WCAP-12345
REVISION 1

WESTINGHOUSE OWNERS GROUP

IRRADIATION EFFECTS
ON
REACTOR VESSEL SUPPORTS

FIGURE 2-3

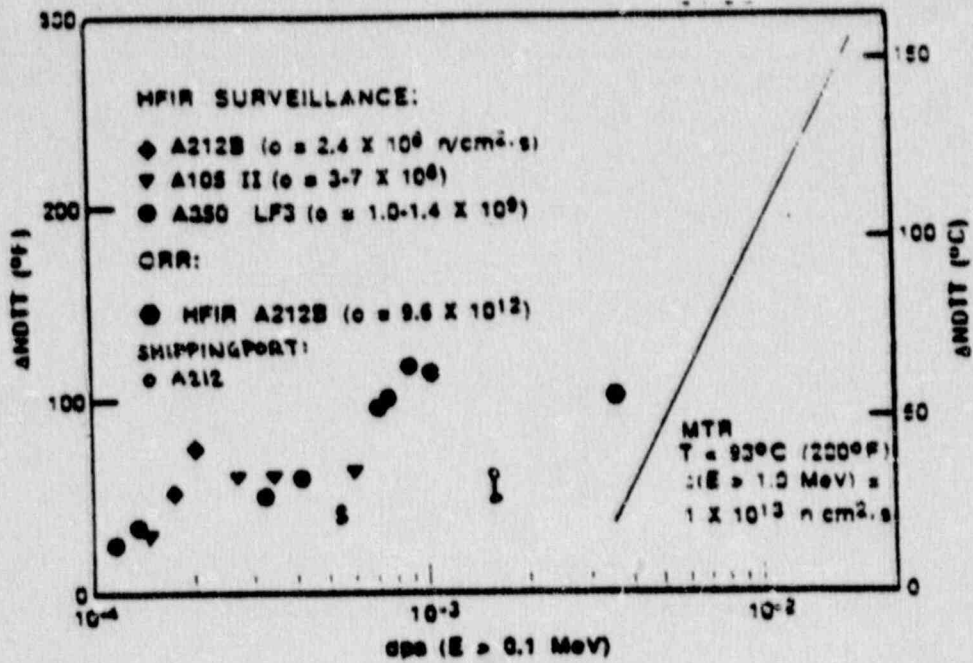
The surveillance results from the HFIR reactor are shown in Figure 2-3. Note that the data all still fit within the 75-90 tolerance bounds developed by Porter. Looking at the data by themselves shows a different slope than Porters, but there appears to be a good reason for such a disparity. The HFIR reactor contains a thick beryllium reflector which prevents a large percentage of the high energy neutrons from reaching the tank wall. Therefore the dpa is a much more accurate measure of total

The HFIR results are not typical of those for a power reactor, because the energy spectrum has such a low proportion of low energy neutrons. It is our belief that use of these results is misleading for the vessel support issue. The more appropriate data are from Shippingport, and they match Porter's data very well. Porter's data base was used in earlier years to conclude that no integrity issue exists for low fluences, and the same conclusion appears to hold today. The fluence calculations need to be redone for the HFIR reactor, and the whole issue reassessed at that time.

FIGURE 2-4

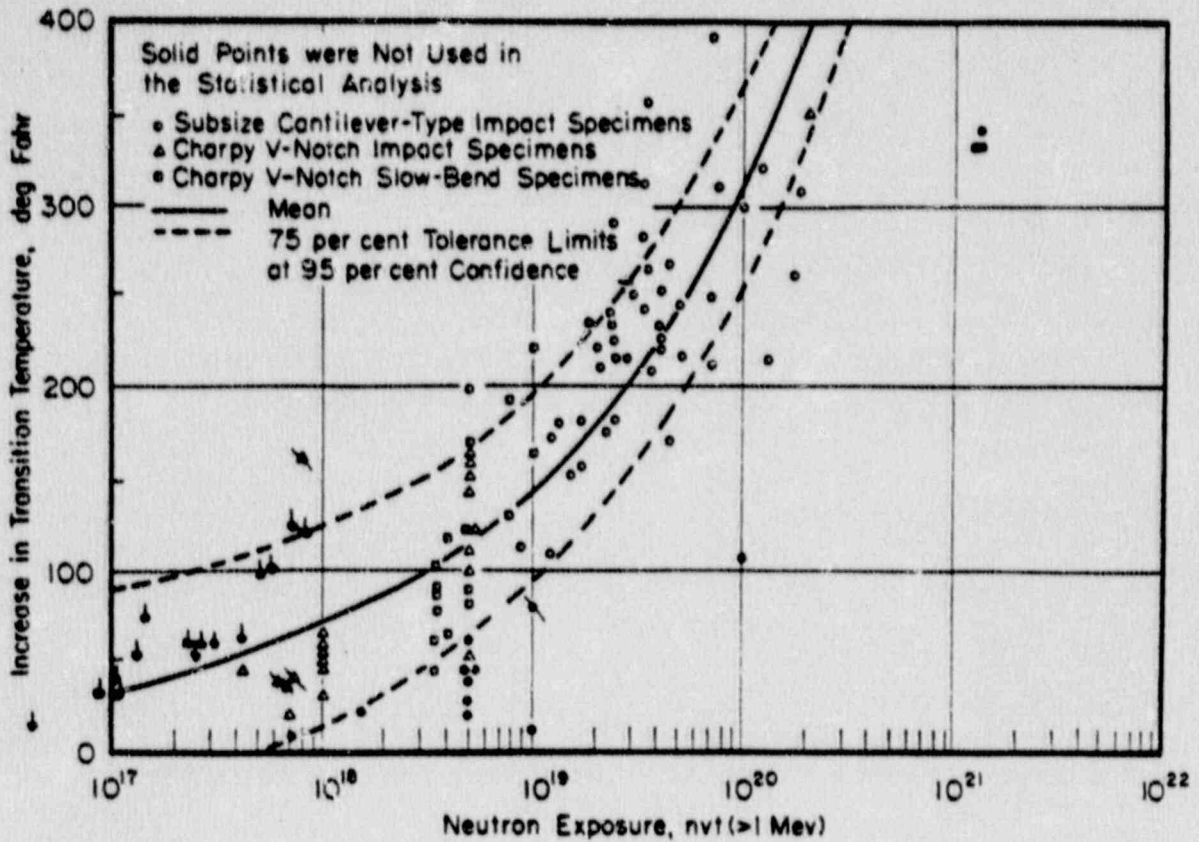
irradiation exposure. The Shippingport and HFIR results compare better based on dpa, as seen in Figure 2-4, but the comparison is marred by the ORNL calculation, which considered only energies greater than 0.1 MeV. This calculation should be redone to consider all energies, as the Shippingport calculations have done. An example of the energies missed in the ORNL calculation is given in table 2-3. Figure 2-5 shows the HFIR results in terms of both fluence (> 1 Mev), and dpa (>0.1 Mev) and illustrates the different slopes which result.
